Application for change or cancellation of resource consent condition (S.127)

8. Detailed description of the proposal:		
This application relates to the following resource consent:		
Specific conditions to which this application relates:		
Describe the proposed changes:

- 1.9. RC 2250199-RMALUC is to 'undertake earthworks, construct retaining walls and install stormwater control measures within 20m of a Scheduled Heritage Resource'. A copy of the approved resource consent and plans is attached at **Appendix 5**.
- 1.10. The table below sets out the variation to the proposed activities. The proximity of earthworks and retaining walls (buildings) within 20m of a Scheduled Heritage Resource requiring resource consent under the PDP has not changed. There is an overall reduction in the size and scale of remedial repair works being undertaken within the Hall site.

1.14. To enable the revised design, the application seeks to vary the following conditions as follows:

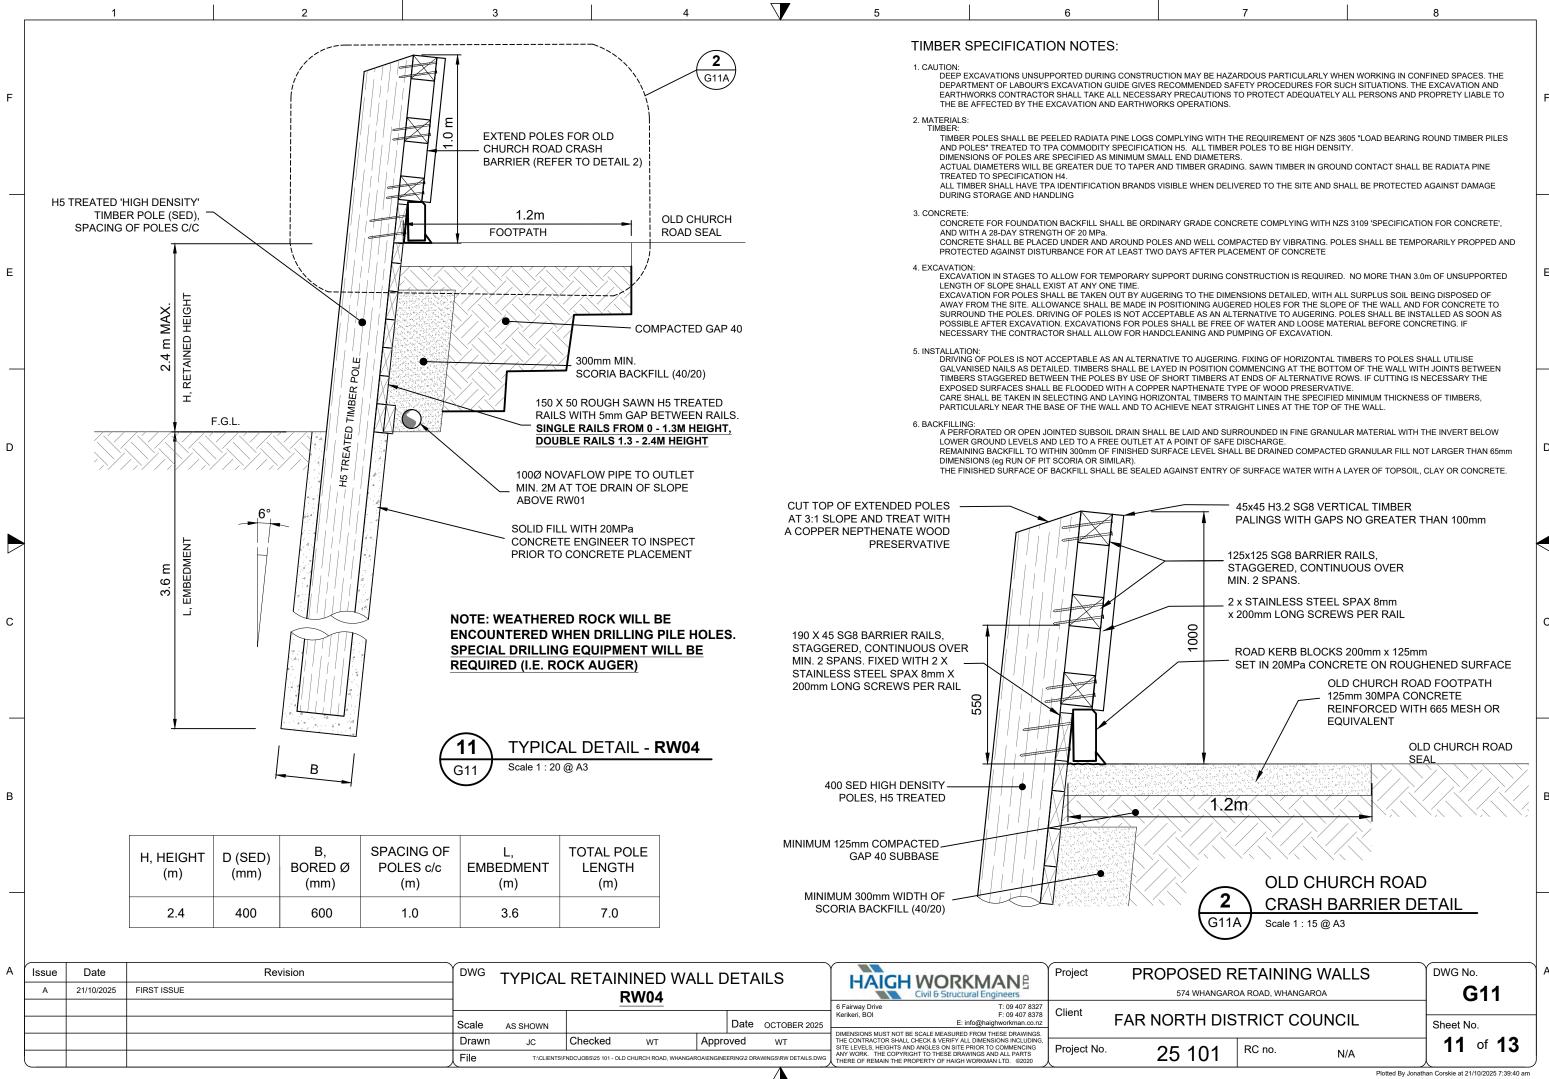
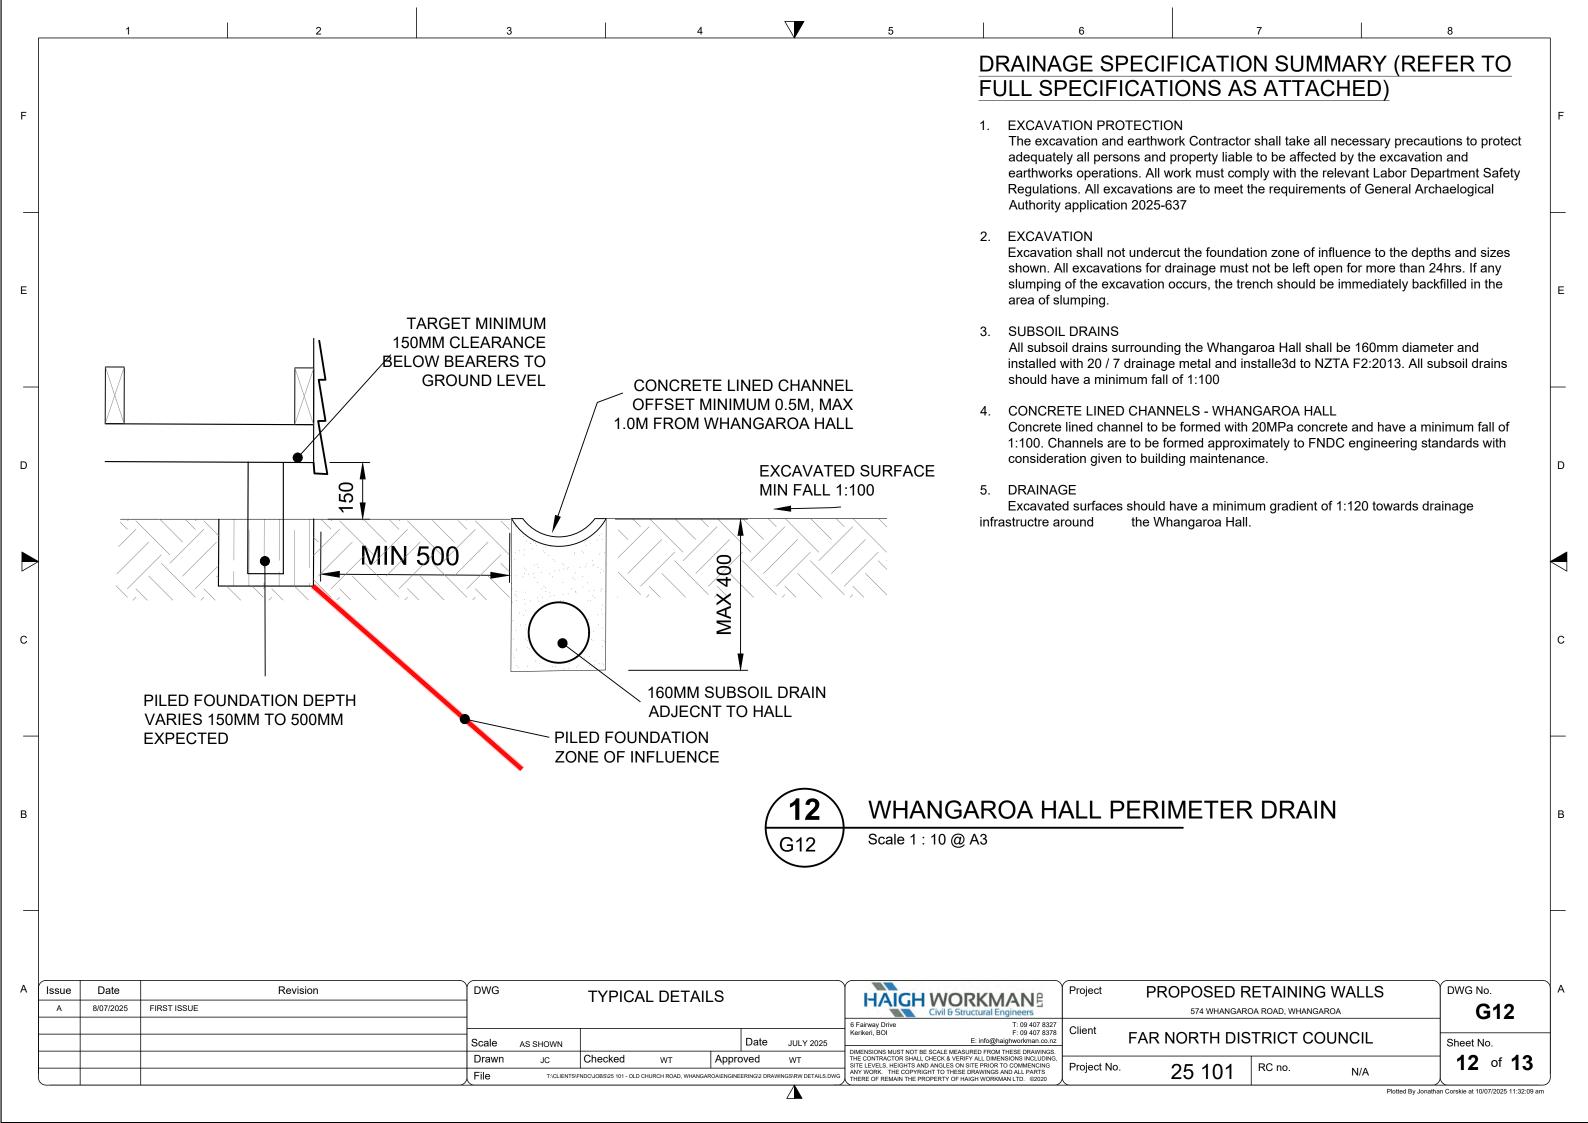
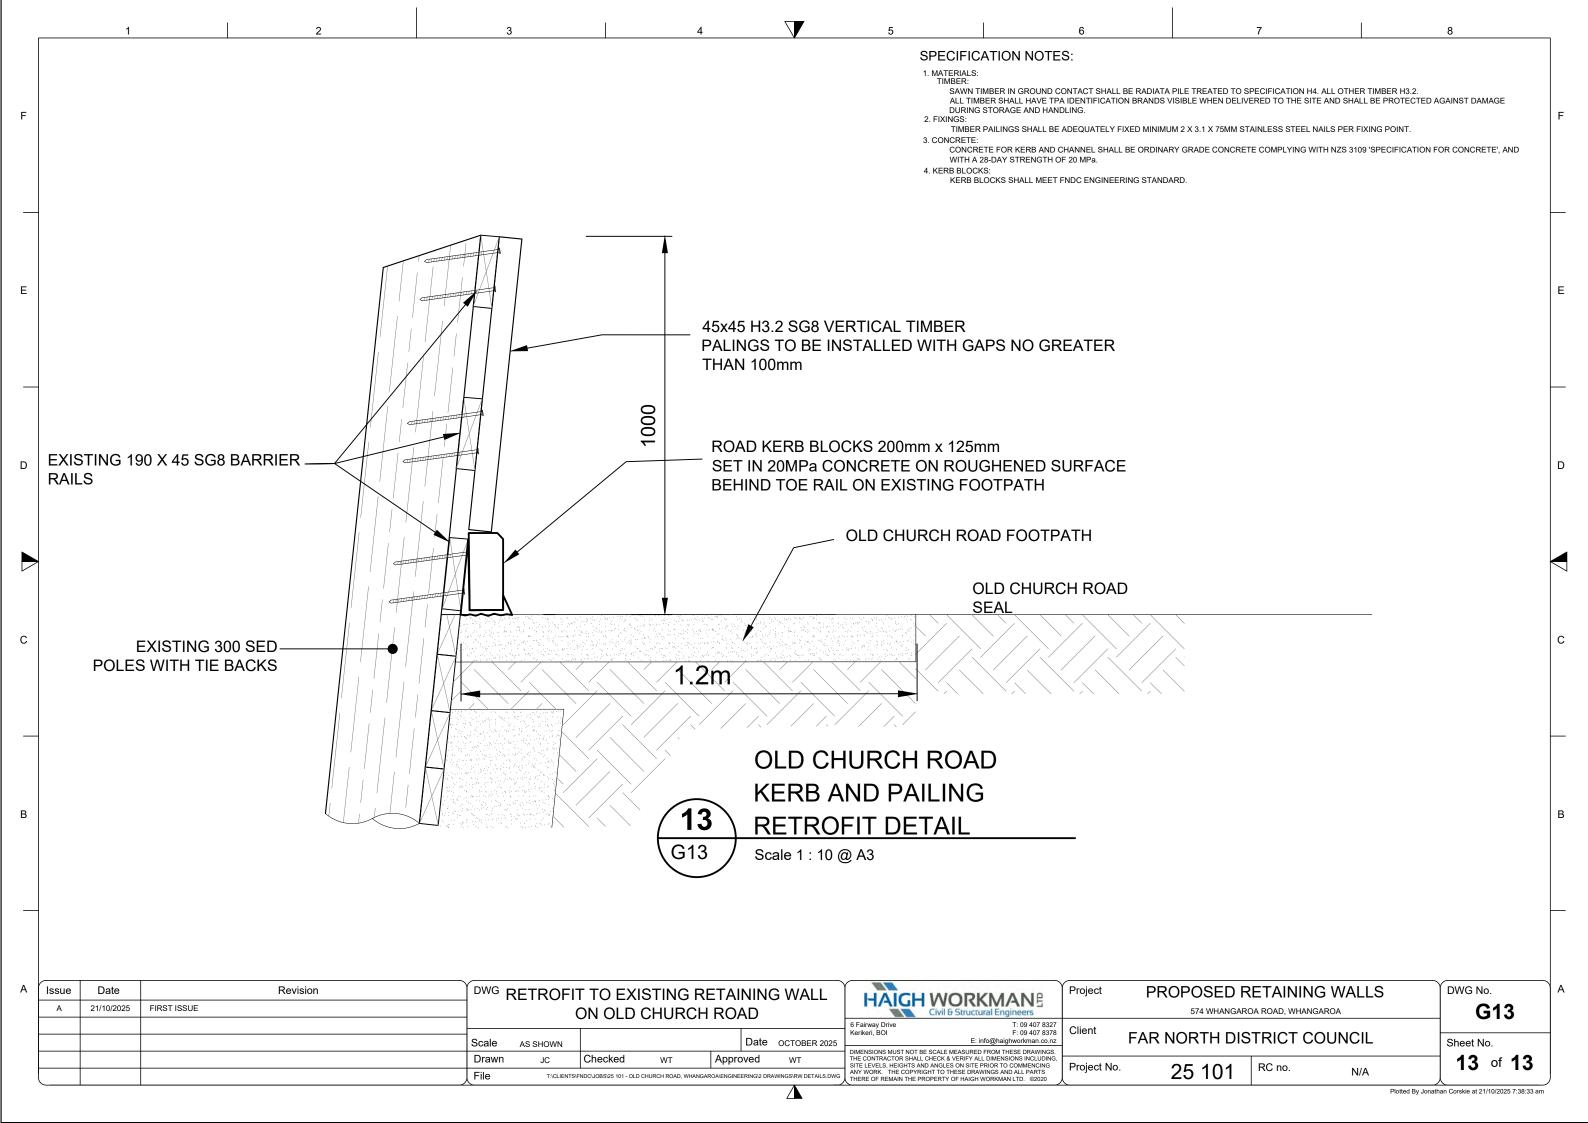
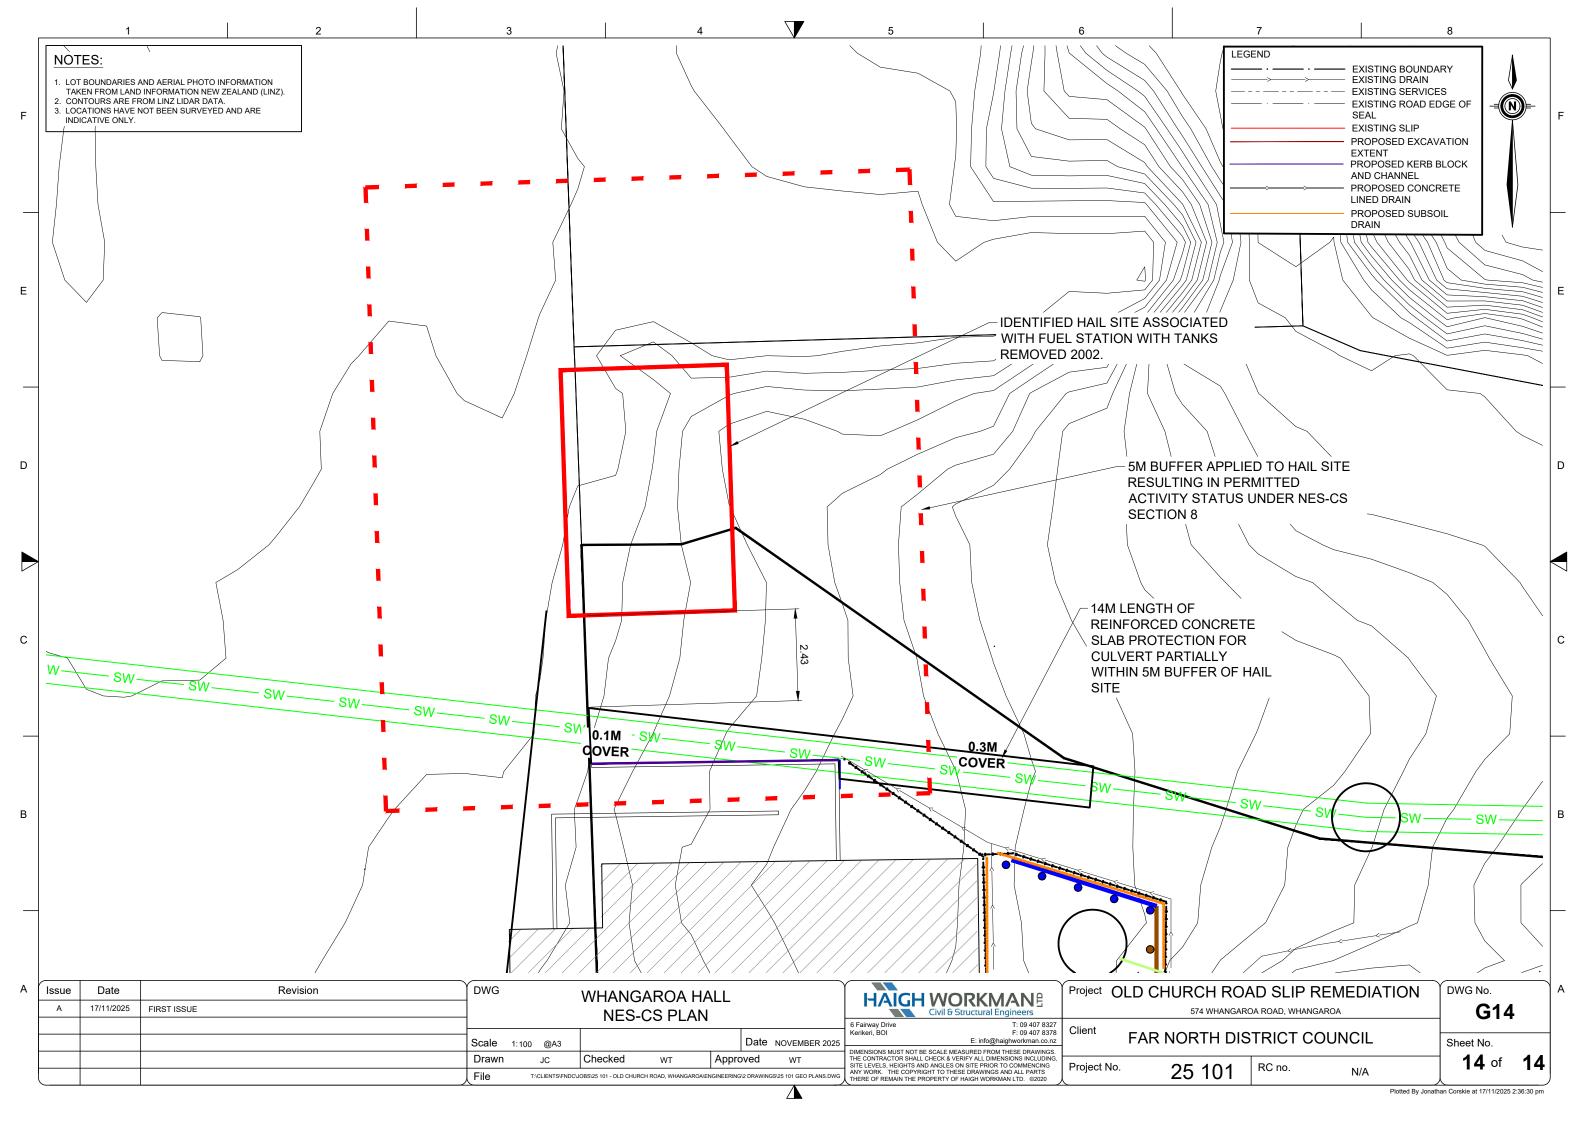
Consented Activity	Variation Proposal	
Excavation Earthworks		
Volume = 50m ³	Volume = 35m ³	
Depth = 300mm	Depth = 150mm	
Approved Plan G02	Revised Plan G03 & G07	
Retaining Walls		
RW01		
Height = 1m	Height = 1m	
Length = Not specified	Length = 7.2m	
Approved Plan(s) G01 & G04	Proposed Plan(s) G05 & G08	
RW02		
Height = 1m	Height = 0.75m

Length = Not specified	Length = 3.6m
Approved Plan(s) G01 & G05	Proposed Plan(s) G05 & G09
RWO3	
Height = 1m	Height = 0.5m
Length = Not specified	Length = 4.1m
Approved Plan(s) G01 & G06	Proposed Plan G05 & G10
Stormwater Drainage	
Dish drain above retaining wall to divert	Subsoil drains and concrete lined channel behind
stormwater entering the side in a	retaining walls to direct stormwater around
westward direction.	perimeter of the building to Whangaroa Road
	street drainage via existing stormwater culvert
	on northern side of building and concrete lined
	channel on southern side.
Approved Plan G01	Proposed Plan G07

- 1.12. As shown on the Stormwater and Drainage Plan G07, new subsoil drains and a concrete lined channel will be installed along the southern and eastern sides of the Hall building to direct stormwater westward to the kerb drainage on Whangaroa Road. On the northern side of the Hall building, stormwater from subsoil drains and a new concrete lined channel drain above the retaining wall will be conveyed to an existing FNDC stormwater culvert. The concrete lined channel will prevent overland stormwater flows from entering the Whangaroa Hall building footprint. Works involving the installation of a reinforced concrete slab required to strengthen the existing culvert will be undertaken. A new kerb block and channel will be constructed along the northern side of the Hall building adjacent to the access ramp. The proposed concrete slab protection works to the existing stormwater culvert on the northern side of the building will be undertaken adjacent to an identified HAIL site that is a former petrol station.

Condition 1 – The activity shall be carried out in general accordance with the approved plans prepared by Haigh Workman Ltd, referenced 24 079 25 101, dated 'May 2024, and attached to this consent with the Council's "Approved Stamp" affixed to them.

NB: The revised plans to be included in the approved plan set are set out in paragraph 1.4 above. There are various plan dates so suggest these are listed in the consent condition 1.
